County of Hawai'i PLANNING DEPARTMENT

SUBJECT: **Application:** **PLANNED UNIT DEVELOPMENT (PUD-15-000033)**
 Applicant: **FENWAY DEVELOPMENT, INC.**
 Owners: **WILCREST PADS, LTD, FEAGAN SHEPHERD, LTD, MAIN**
 BUFFALO INVESTMENTS, LTD.

Request: **PUD: KUALONO**
 Tax Map Key: **7-9-005:078 & 087**

Exhibit 3: Yard Designation
 Variance Request - Zoning Code

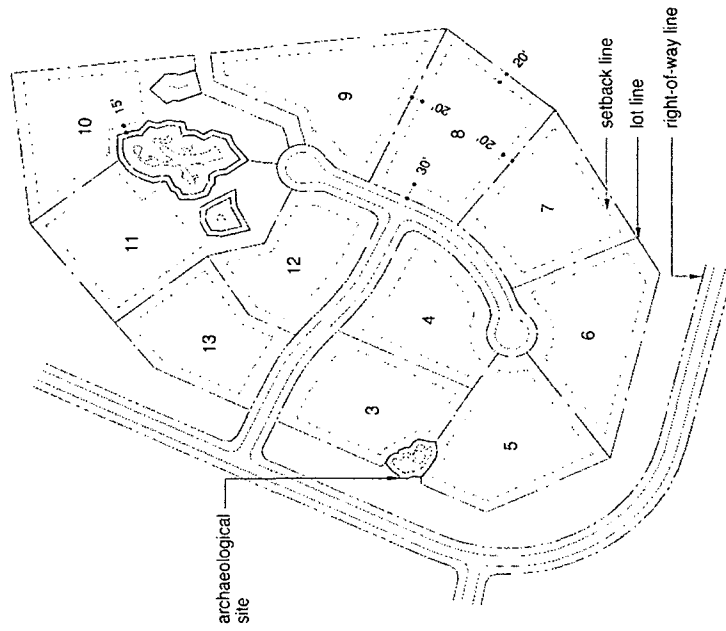
Request:
 The Petitioner request the yards be designated as indicated below.

All front yards shall be 30 feet
 All rear yards shall be 20 feet
 All side yards shall be 20 feet
 All yards adjacent archaeological sites shall be designated as 15 foot side yards from edge of buffer line.

Exhibit 2: Yard Designation
 Variance Request - Zoning Code

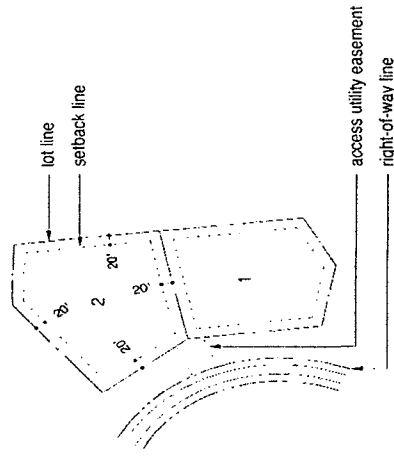
Request:
 The Petitioner request the yards be designated as indicated below.

All yards these lots shall be designated as 20 foot side yards.

Exhibit 5: Yard Designation Variance Request - Zoning Code

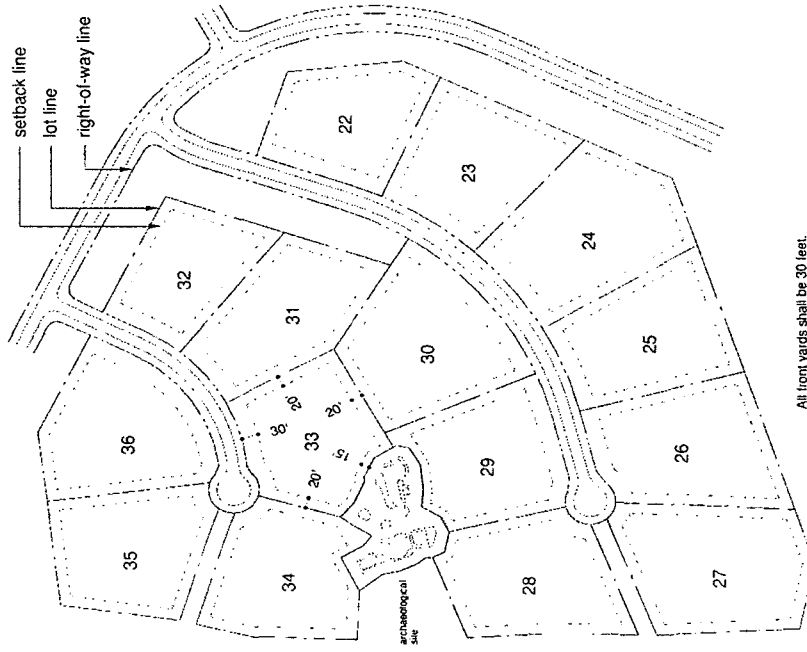
Request:
The Petitioner request the yards be designated as indicated below.

All front yards shall be 30 feet.
All rear yards shall be 20 feet.
All side yards shall be 20 feet.
All yards adjacent archaeological sites shall be designated as 15 foot side yards from edge of buffer line.

Exhibit 4: Yard Designation Variance Request - Zoning Code

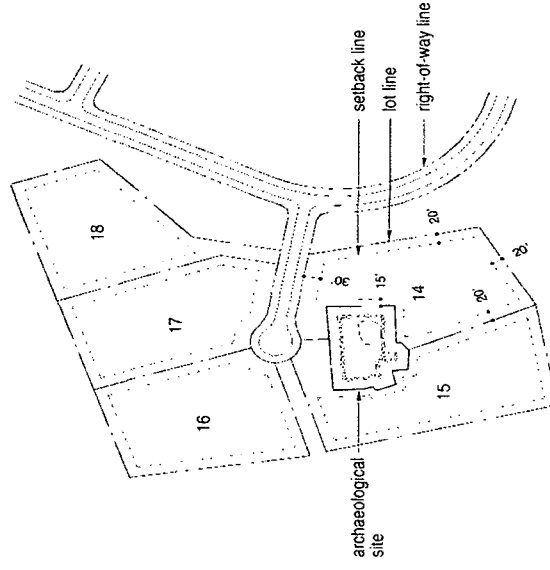
Request:
The Petitioner request the yards be designated as indicated below.

All front yards shall be 30 feet.
All rear yards shall be 20 feet.
All side yards shall be 20 feet.
All yards adjacent archaeological sites shall be designated as 15 foot side yards from edge of buffer line.

Exhibit 7: Yard Designation
 Variance Request - Zoning Code

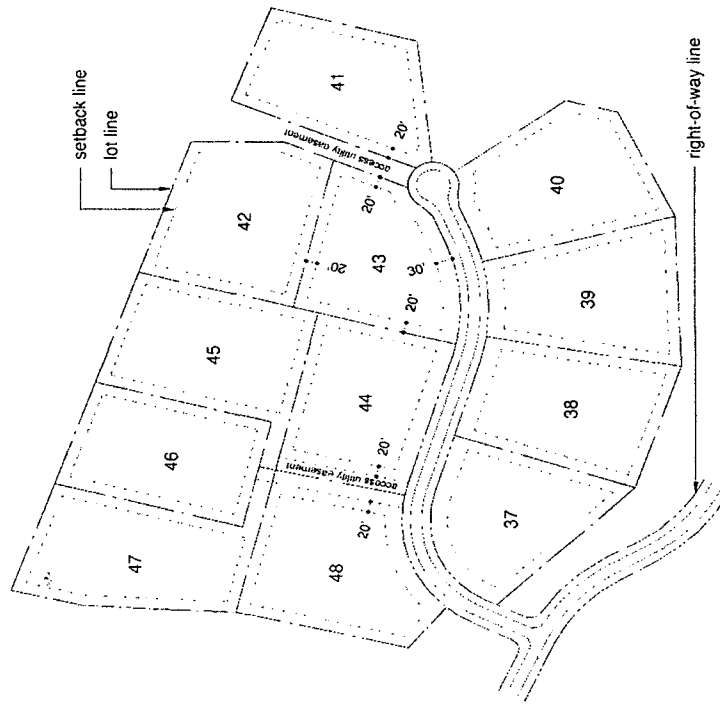
Request:
 The Petitioner request the yards be designated as indicated below.

All front yards shall be 30 feet.
 All rear yards shall be 20 feet.
 All side yards shall be 20 feet.

Exhibit 6: Yard Designation
 Variance Request - Zoning Code

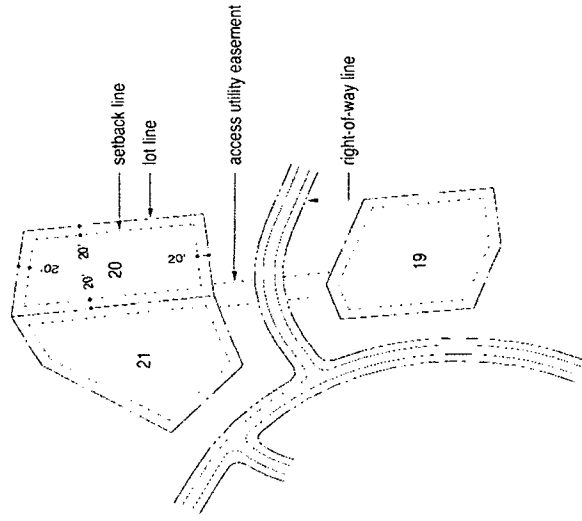
Request:
 The Petitioner request the yards be designated as indicated below.

All yards these lots shall be designated as 20 foot side yards.

Exhibit 8: Cul-de-Sacs

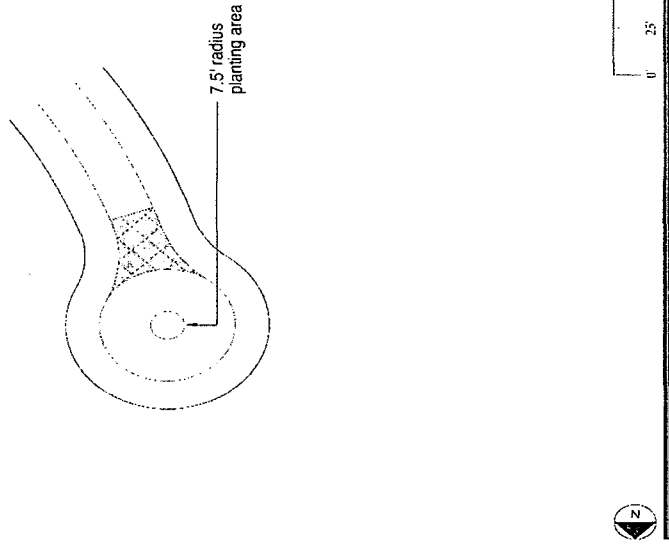
The Petitioner request the cul-de-sac be permitted to have a center planting area as indicated below:

Exhibit 11: Right of Way Improvement

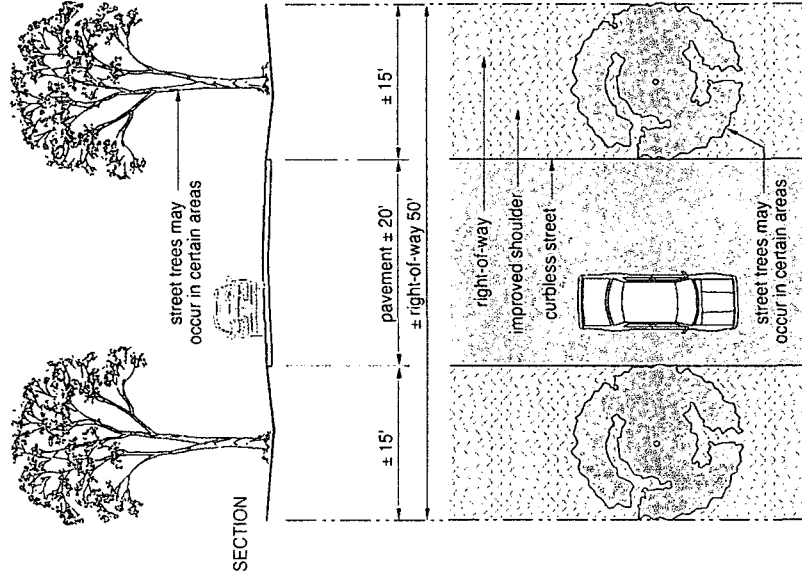
The Petitioner request that the requirements of Section 23-95 be waived to allow design flexibility in the treatment of the right of way areas as indicated below:
